Proposal for the 07 Series of Amendments to Regulation No. 46 (Devices for Indirect Vision)

Submitted by the expert from Germany on behalf of the Task Force on UN Regulation No. 46*

Figure 1a

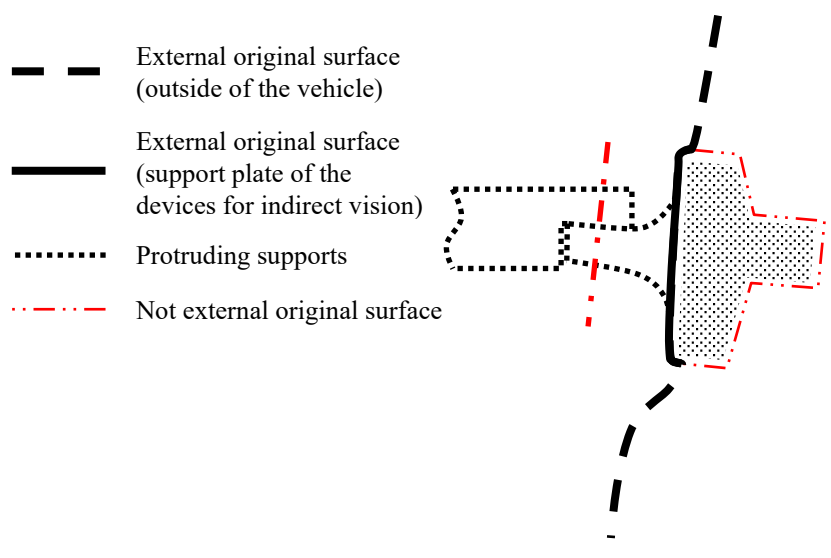
"2.7. "External original surface" means the outside of the vehicle including the bonnet, the lid of the luggage compartment, the doors, the wings (**fender**), the roof, the lighting and light-signalling devices, the visible strengthening components, **the support plate of devices for indirect vision** and additional external original design surfaces defined by the manufacturer excluding protruding supports for devices of indirect vision.

7. Clarification on external original surface: A drawing shall be added to further explain the idea of "external original surface". Additionally, the wording in paragraph 6.1.1.6. shall be amended for clarity.

Figure 1b
Example for the Measurement by Maximum Variation

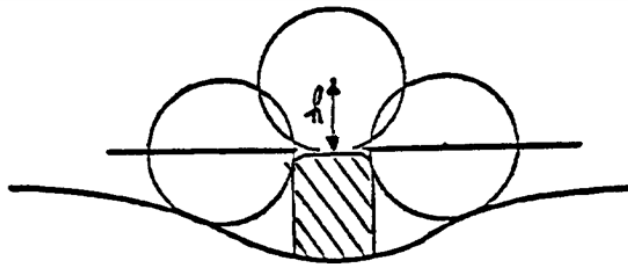
"6.1.1.4.2. If the dimension of the projection of a component which is mounted on a surface other than convex cannot be determined by simple measurement, it shall be determined by the maximum variation of the distance of the centre of a 100 mm diameter sphere from the nominal line of the panel when the sphere is moved over and is in constant contact with that component.
Figure 1b shows an example of the use of this procedure.

11. Correct the numbering of the figures: In the current version there are two different figures numbered 1. As a new figure shall be introduced, the new one becomes figure 1a and the former figures 1 become 1b and 1c.

Figure 1b
Example for the Measurement by Maximum Variation

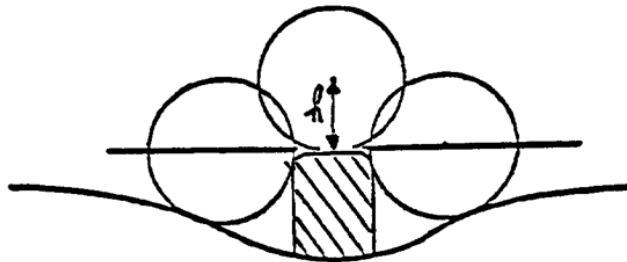
- "6.2.2.1.2.2. If the dimension of the projection of a component which is mounted on a surface other than convex cannot be determined by simple measurement, it shall be determined by the maximum variation of the distance of the centre of a 100 mm diameter sphere from the nominal line of the panel when the sphere is moved over and is in constant contact with that component. Figure 1b shows an example of the use of this procedure.

Figure 1c

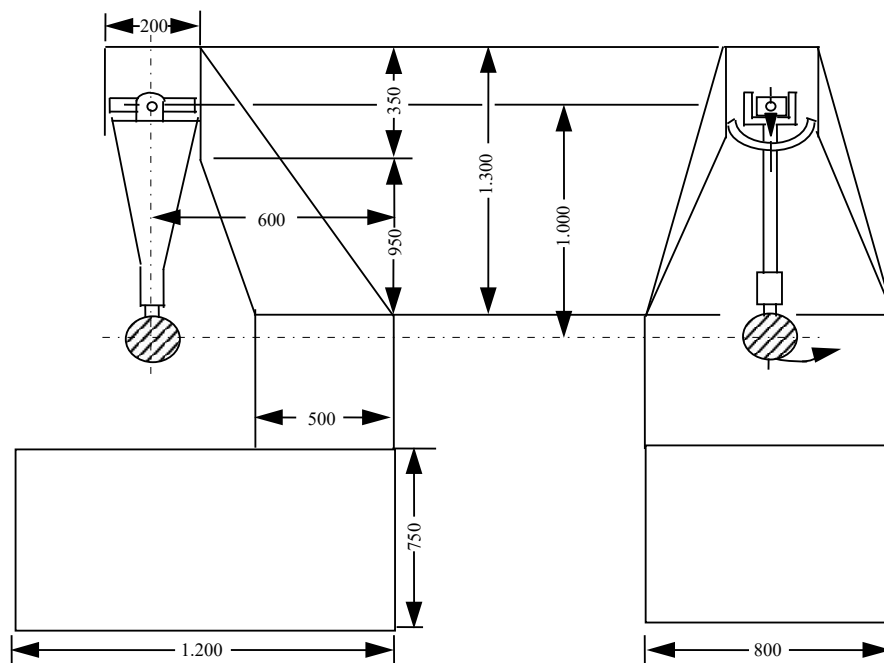
The end of the pendulum comprises a hammer formed by a rigid sphere with a diameter of 165 ± 1 mm, and **at least on the impact side** a 5 ± 1 mm thick rubber covering of Shore A hardness 50.

The end of the hammer may be formed by any other rigid shape having at least on the impact side a spherical shape and a 5 ± 1 mm thick rubber covering of Shore A hardness 50, if the equivalence of this shape is demonstrated through a mathematical model, to the satisfaction of the Type Approval Authority.

9. Pendulum Test: This proposal adds more flexibility in the shape of the hammer. Alternatives to the sphere shall be accepted, if at least on the impact side is a spherical shape. In addition, it shall be sufficient to have a rubber cover at the impact side. All requirements per paragraph 6.3.2.1.2. still need to be fulfilled.

Figure 5
Class II fields of vision

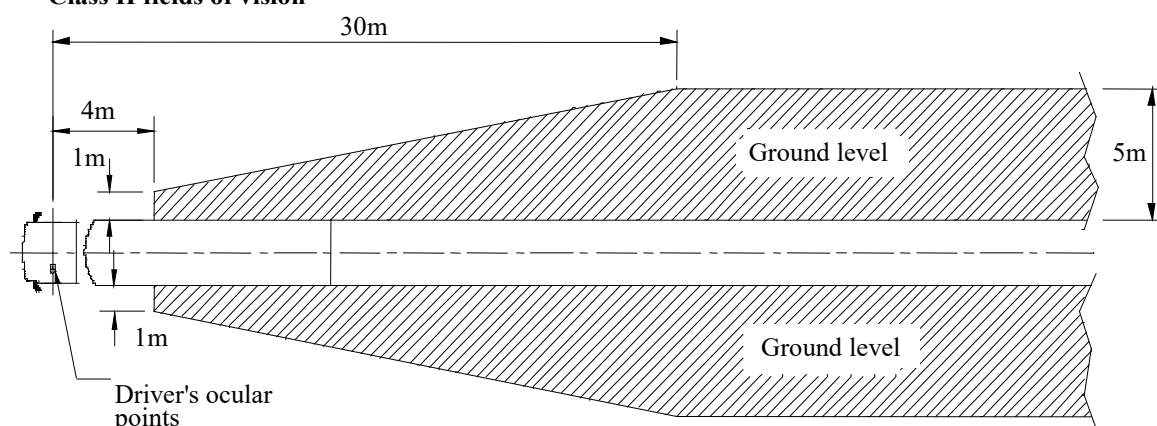
In addition, the road shall be visible to the driver over a width of 1 m, which is bounded by a plane parallel to the median longitudinal vertical plane and passing through the outermost point of the vehicle starting from a point 4 m behind the vertical plane passing through the driver's ocular points, **while linearly increasing up to a width of 5 m wide at the point 30 m behind the vertical plane passing through the driver's ocular points** (see Figure 5).

In addition, the road shall be visible to the driver over a width of 1 m, which is bounded by a plane parallel to the median longitudinal vertical plane and passing through the outermost point of the vehicle starting from a point 4 m behind the vertical plane passing through the driver's ocular points, **while linearly increasing up to a width of 5 m wide at the point 30 m behind the vertical plane passing through the driver's ocular points** (see Figure 5)."

4. Paragraphs 15.2.4.2. to 15.2.4.4. have been updated to have the text reflect what the figures 5, 6 and 7 indicate. In the text, only 2 distances are mentioned, whereas the figures indicate that the area in between the lines constitute of a linear progress between the first line and the other line.

Figure 6
Class III fields of vision

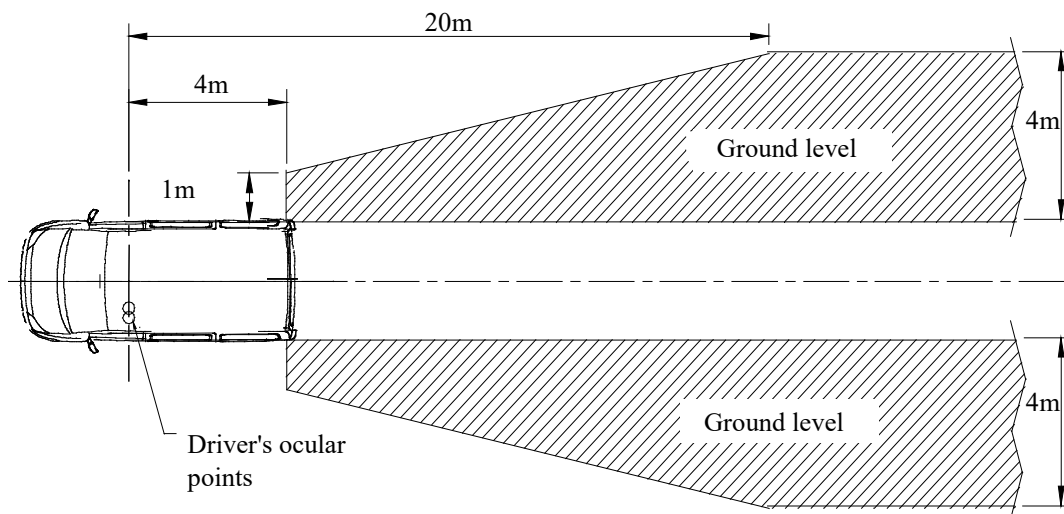
In addition, the road shall be visible to the driver over a width of 1 m, which is bounded by a plane parallel to the median longitudinal vertical plane and passing through the outermost point of the vehicle starting from a point 4 m behind the vertical plane passing through the driver's ocular points, **while linearly increasing up to a width of 4 m wide at the point 20 m behind the vertical plane passing through the driver's ocular points.**

In addition, the road shall be visible to the driver over a width of 1 m, which is bounded by a plane parallel to the median longitudinal vertical plane and passing through the outermost point of the vehicle starting from a point 4 m behind the vertical plane passing through the driver's ocular points, **while linearly increasing up to a width of 4 m wide at the point 20 m behind the vertical plane passing through the driver's ocular points."**

Figure 7
Class IV fields of vision

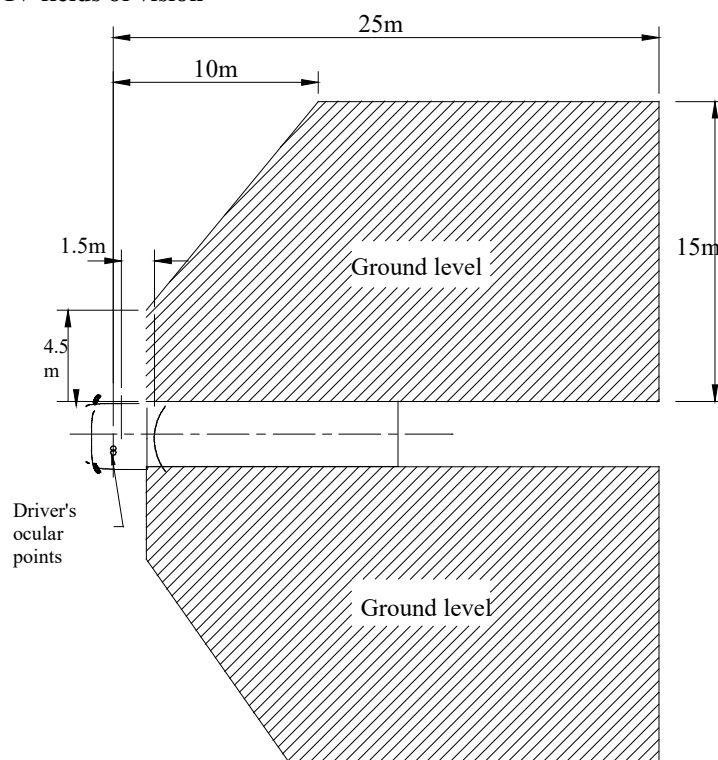
In addition, the road shall be visible to the driver over a width of 4.5 m, which is bounded by a plane parallel to the median longitudinal vertical plane and passing through the outermost point of the vehicle starting from a point 1.5 m behind the vertical plane passing through the driver's ocular points, **while linearly increasing up to a width of 15 m wide at the point 10 m behind the vertical plane passing through the driver's ocular points** (see Figure 7).

In addition, the road shall be visible to the driver over a width of 4.5 m, which is bounded by a plane parallel to the median longitudinal vertical plane and passing through the outermost point of the vehicle starting from a point 1.5 m behind the vertical plane passing through the driver's ocular points, **while linearly increasing up to a width of 15 m wide at the point 10 m behind the vertical plane passing through the driver's ocular points** (see Figure 7)."

Example 1

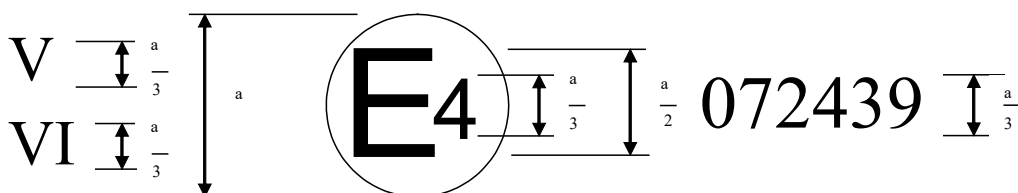
The above approval mark affixed to a device for indirect vision indicates that the device is a main rear-view device, of Class II, which has been approved in the **Kingdom of the Netherlands** (E 4) pursuant to Regulation No. 46 and under approval number **052439 072439**. The first two digits of the approval number indicate that Regulation No. 46 already included the ~~05~~ **07** series of amendments when the approval was granted.

Example 2**One Approval Number for Two Classes**

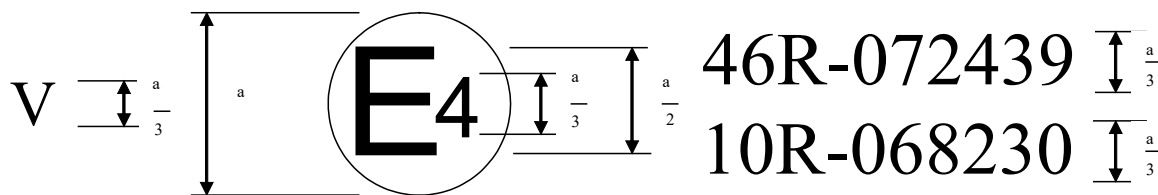
The above approval mark affixed to a device for indirect vision indicates that the device is a close-proximity view device, of Class V, and a front-view device, of Class VI, which has been approved in the **Kingdom of the Netherlands** (E 4) pursuant to Regulation No. 46 and under approval number **072439**. The first two digits of the approval number indicate that Regulation No. 46 already included the **07** series of amendments when the approval was granted.

3. Type-marking: TF decided to introduce the possibility of type-approving devices for more than one "field of view" under one approval number. In addition, it shall be possible to combine the marking of devices for indirect view with the marking of other UN Regulations, e.g. UN Regulation No. 10 on electromagnetic compatibility, if applicable.

Example 3**Combined Approval Mark for UN Regulation No. 46 and UN Regulation No. 10**

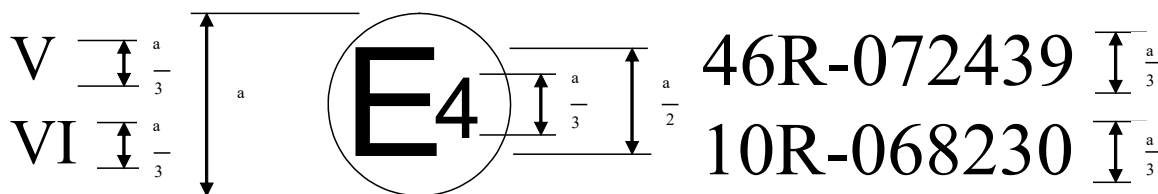
The above approval mark affixed to a device for indirect vision indicates that the device is a close-proximity view device, of Class V, which has been approved in the Kingdom of the Netherlands (E 4) pursuant to Regulation No. 46 and under approval number 072439 and pursuant to Regulation No. 10 and under approval number 068230. The first two digits of the approval number indicate that Regulation No. 46 already included the 07 series of amendments and Regulation No. 10 already included the 06 series of amendments when the approval was granted.
